YEAR 5 (2020) MONITORING REPORT
AYCOCK SPRINGS
STREAM AND WETLAND MITIGATION SITE
ALAMANCE COUNTY, NORTH CAROLINA
DMS PROJECT No. 96312
FULL DELIVERY CONTRACT No. 5791
NCDWR PROJECT No. 20140335
USACE ACTION ID No. SAW-2014-01711

Response to Monitoring Year 5 (2020) DMS Comments

Aycock Springs Stream and Wetland Mitigation Site (DMS #96312)
Cape Fear River Basin 03030002, Alamance County
Contract No. 005791

Aycock Springs Groundwater Gauge 1 Year 5 (2020 Data)

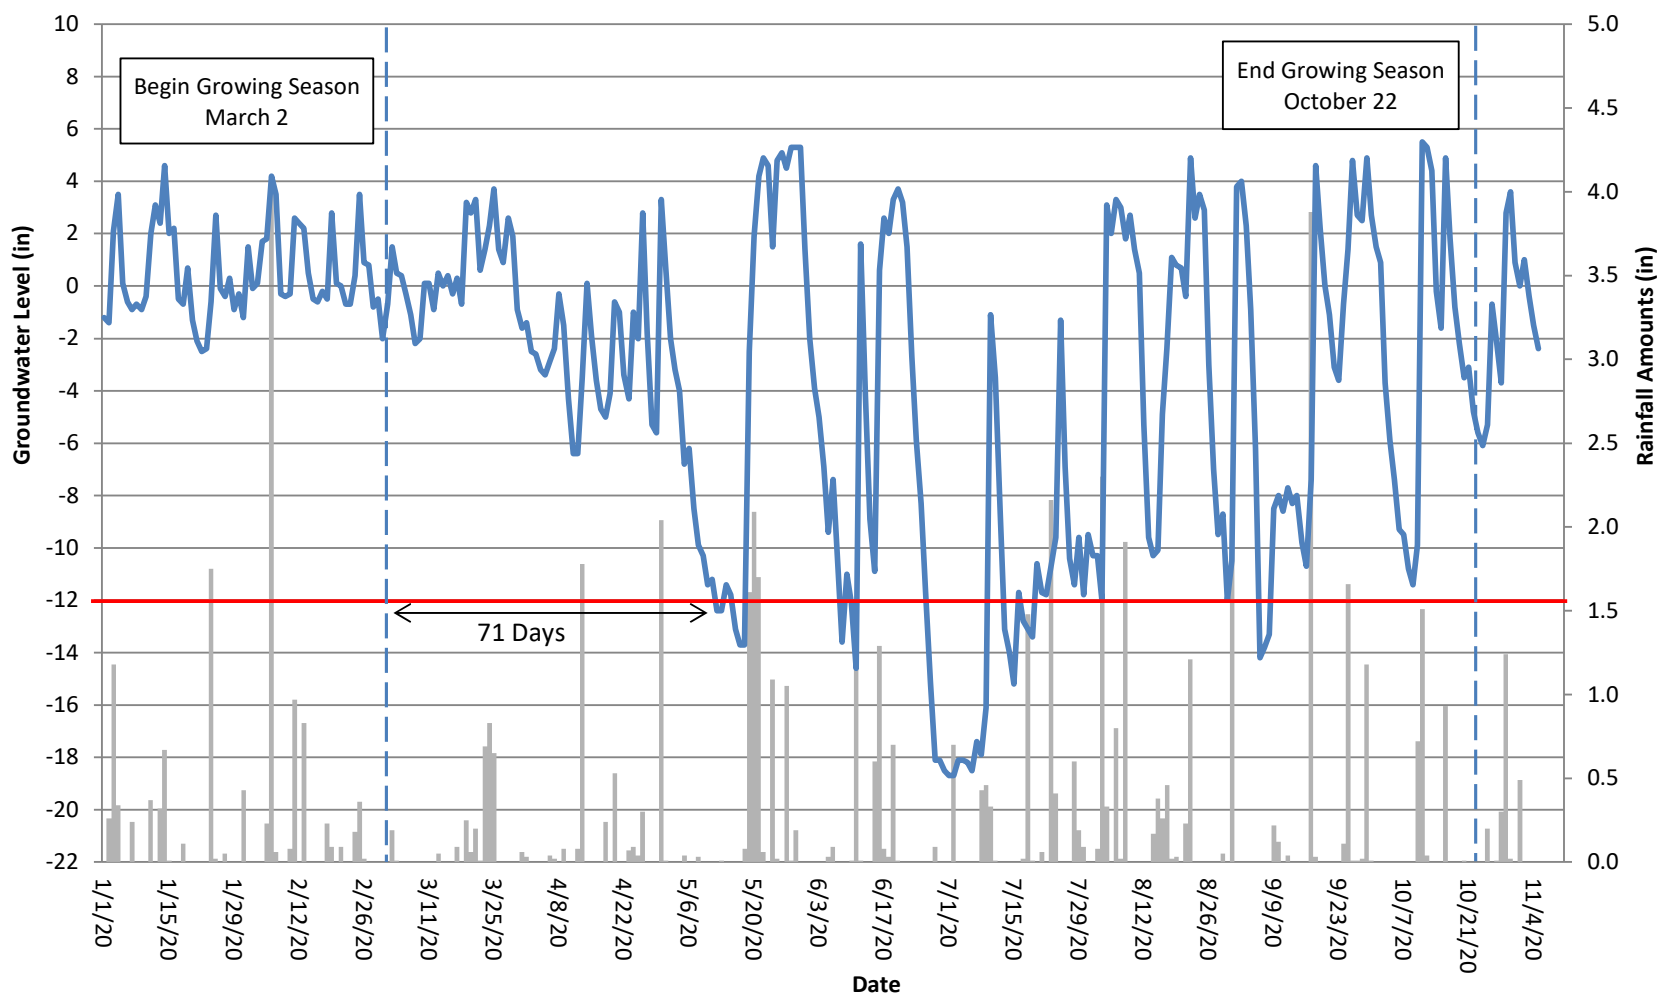
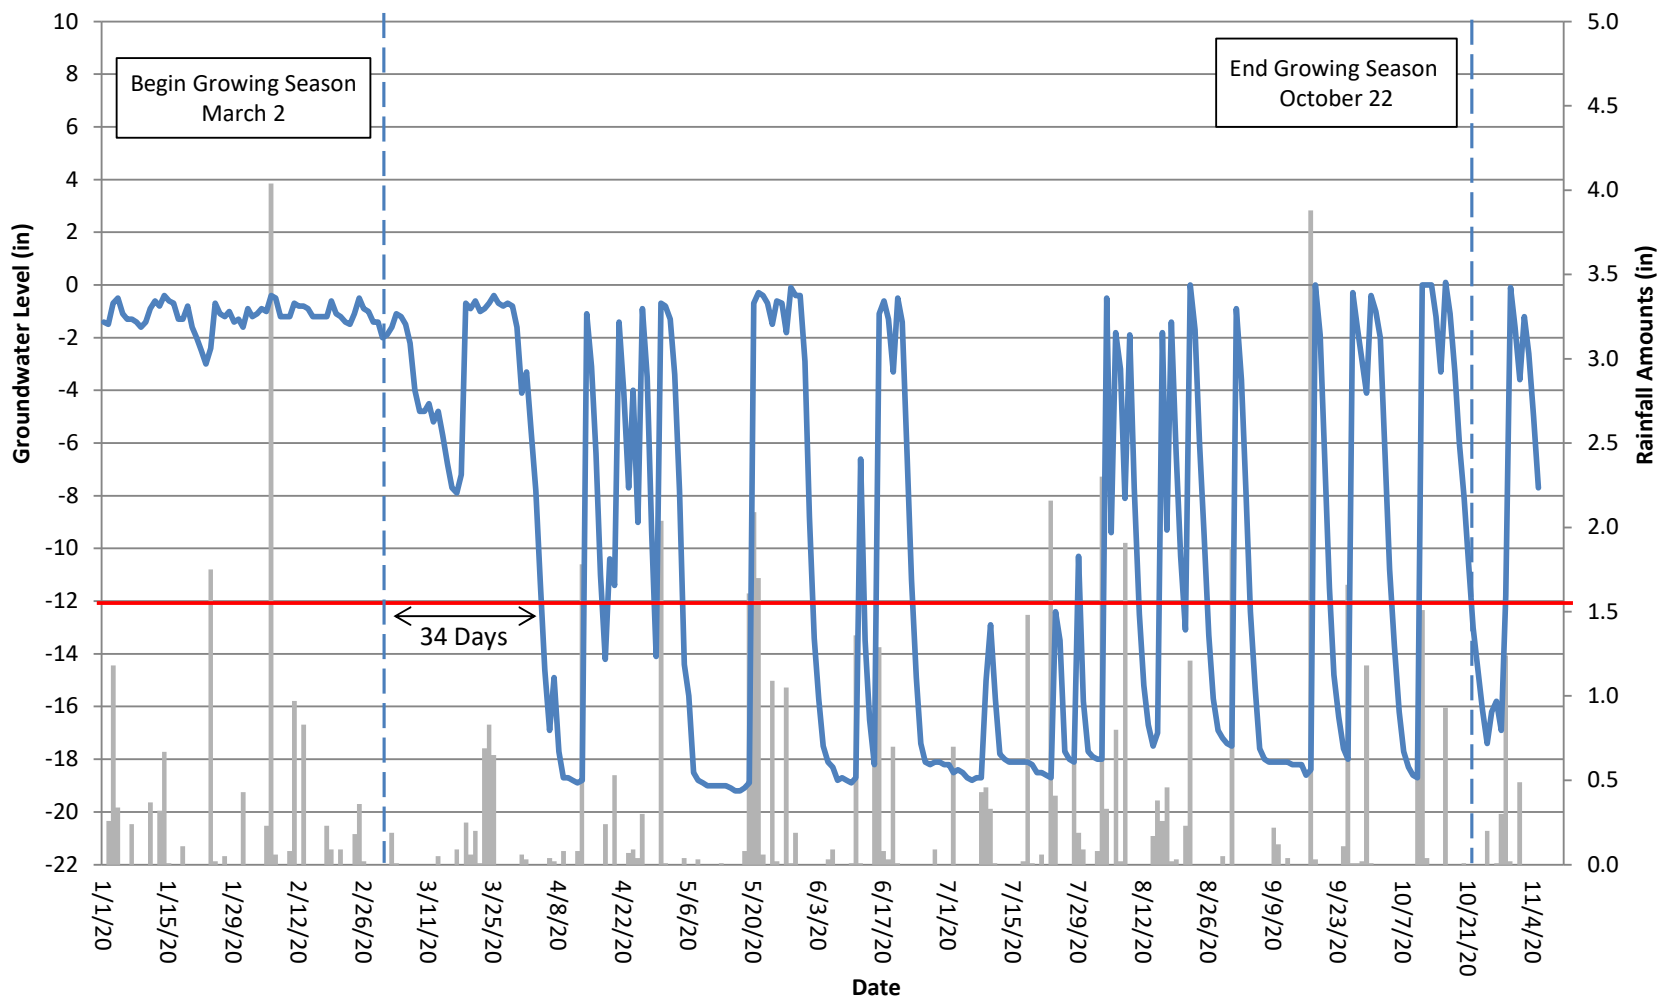
- 3) Appendix E
 - a) Groundwater Gauge Graphs – Please add the graphs, they were not included in the Appendix.
[The gauge graphs were included with this submittal.](#)
